RECEIPT DATE: 11-19-25 **ONSITE SEWAGE DISPOSAL SYSTEM** P 590281

APPROVAL DATE: 1/15/26 **PERMIT: NEW CONSTRUCTION** A _____

PROPERTY ADDRESS: 857 Morgan Station Road

857 MORGAN STATION ROAD
 WOODBINE, MD 21797
 LOT 2, PLAT 18989, MAP 8
 GRID 2, 48,494SF, ACCT#04-593623
 ONSITE SEWAGE DISPOSAL
 SYSTEM DESIGN PLAN

857 MORGAN STATION ROAD
 WOODBINE, MD 21797
 LOT 2, PLAT 18989, MAP 8
 GRID 2, 48,494SF, ACCT#04-593623
 ONSITE SEWAGE DISPOSAL
 SYSTEM DESIGN PLAN

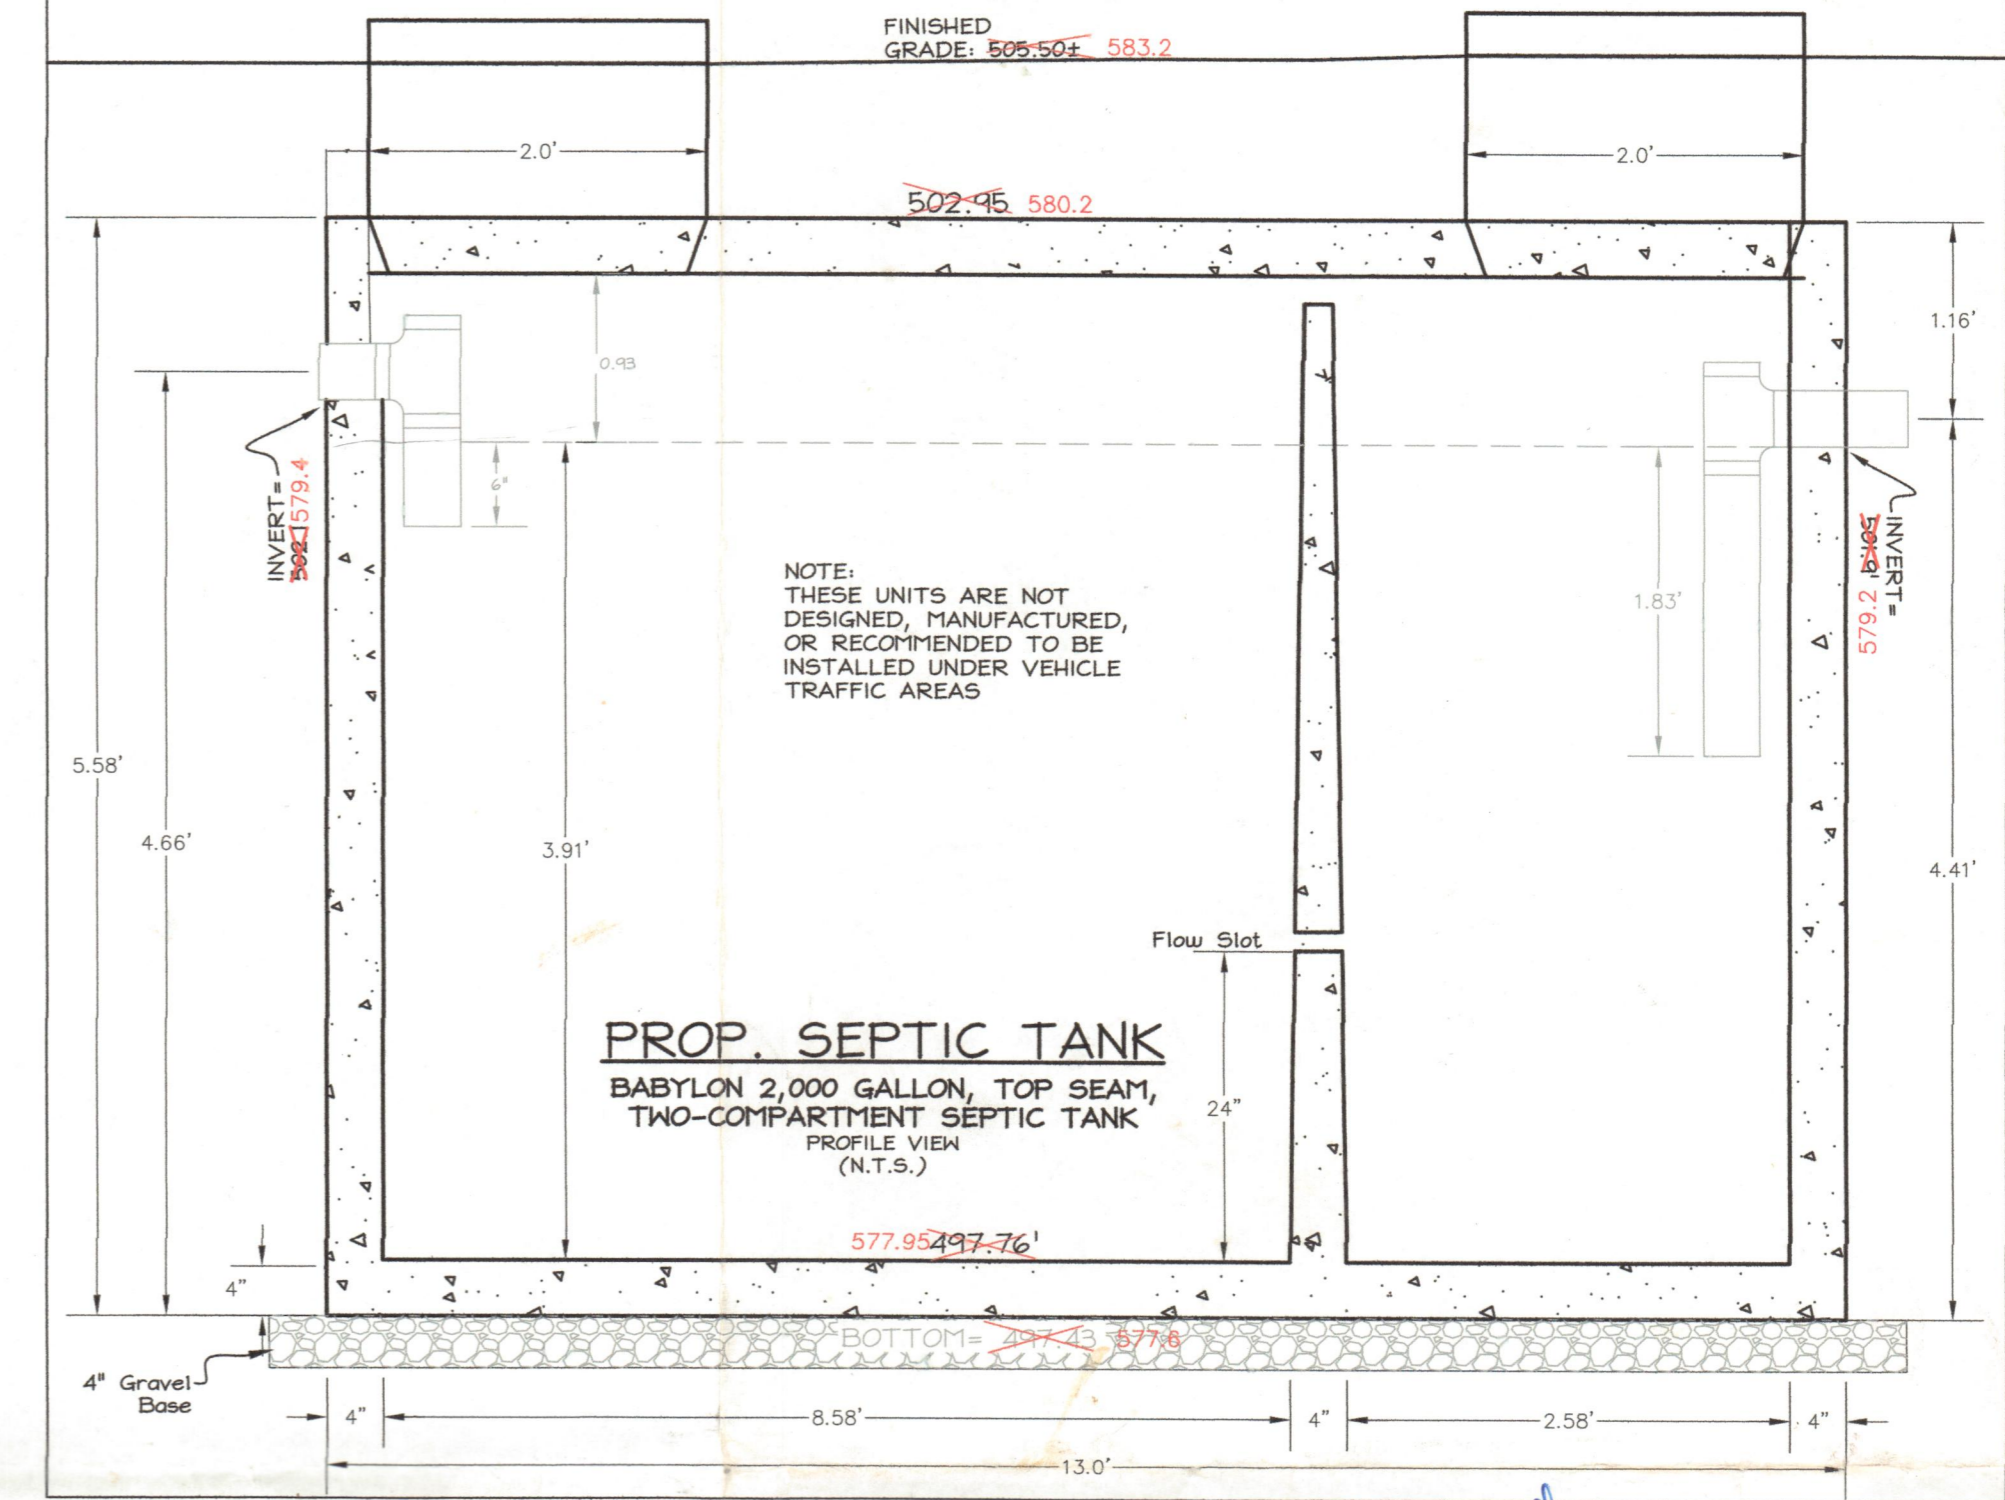
1. **Need to update the plan to reflect a 2000 GAL tank on the plot plan, on the tank detail, and on the septic profile.**
2. **Need all trenches to be 13' apart due to 5' of sidewall credit. [W +D(2)]**
3. **You could put a 22.5 or 45 degree bend in some of the system trenches to get them on contour better. (overall not bad tho)**
4. **Still need to show perc holes & elevations on OSDS.**
5. **Provide exact square footage of well box and SDA.**
6. **Need an updated Perc Cert if changing the well box for Lot 2.**

- A new revised percolation certification plan must be submitted prior to the submission of the OSDS. There have been several changes to this subdivision and the location of the well box has changed on the OSDS submitted.
- When you submit your revised OSDS to reflect your PC please make sure the trenches are on contour.
- The OSDS proposal for your plan shows a 1500-gallon tank and you are proposing a house with 6 bedrooms. You must accommodate the number of bedrooms proposed with a 2000-gallon tank. Please revise.
- The revised PC must match OSDS.

WALL CHECK FOR: 857 MORGAN STATION ROAD

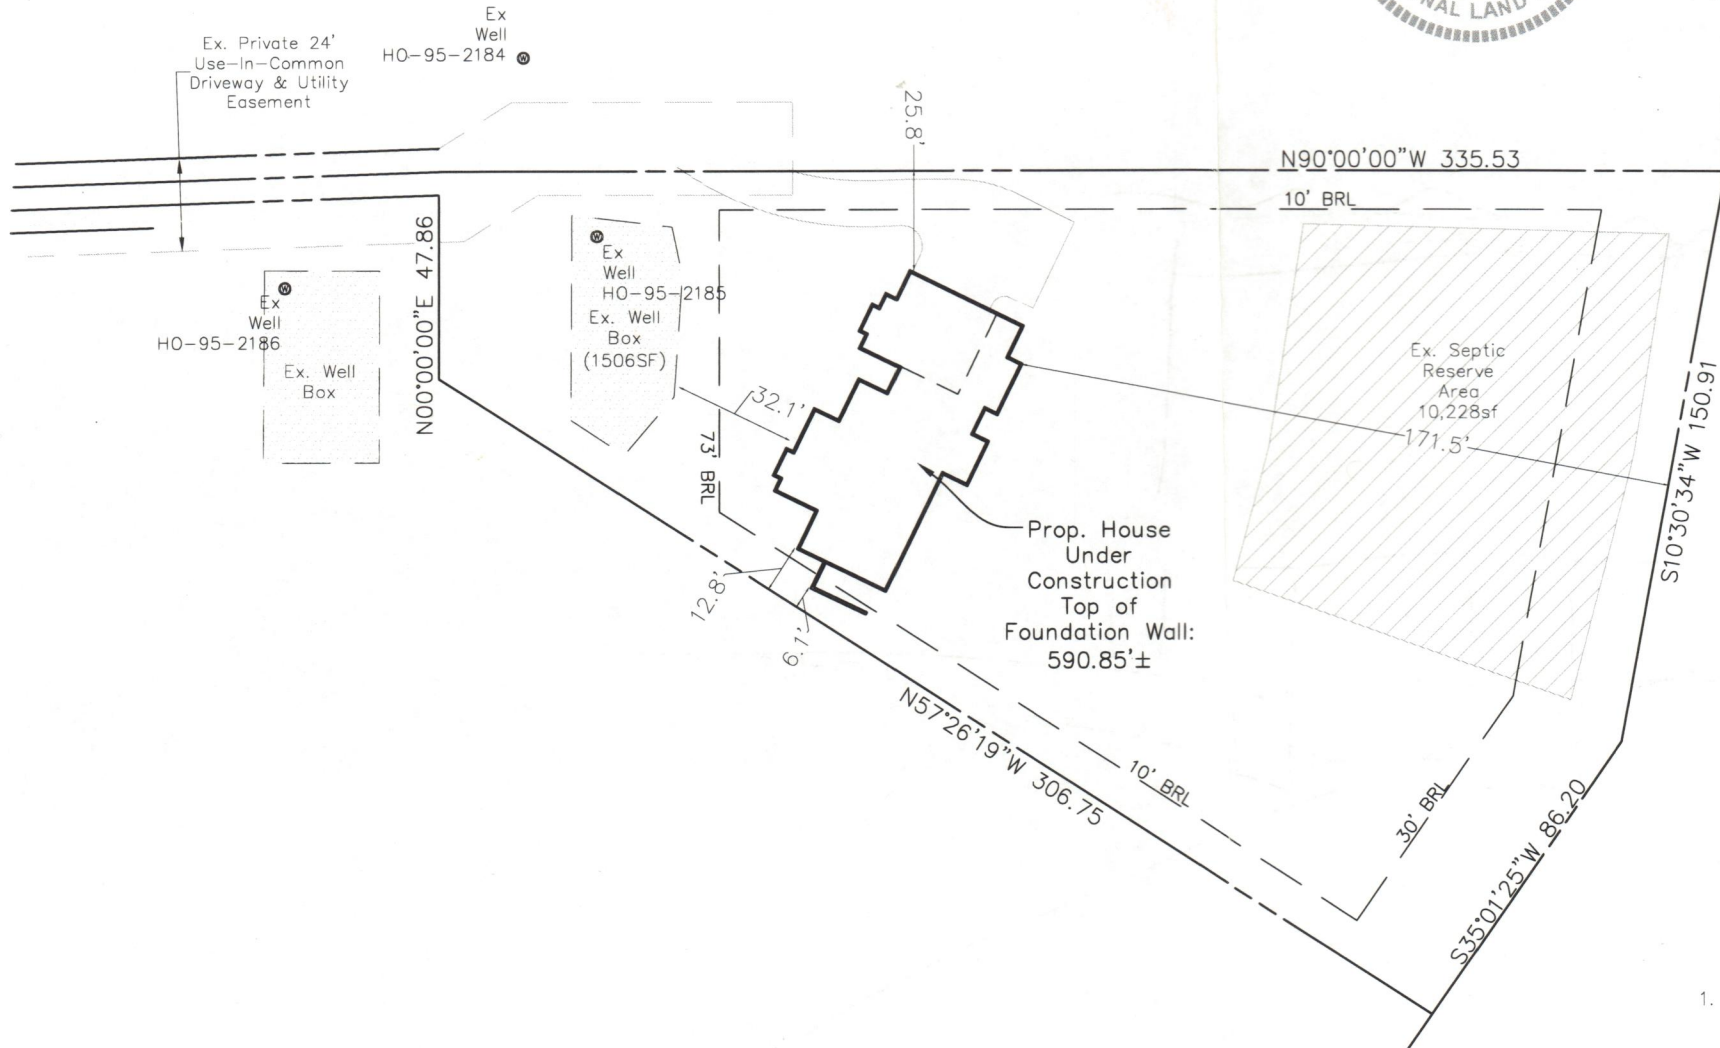
*11/19/25
Wall check
okay. -H.D.*
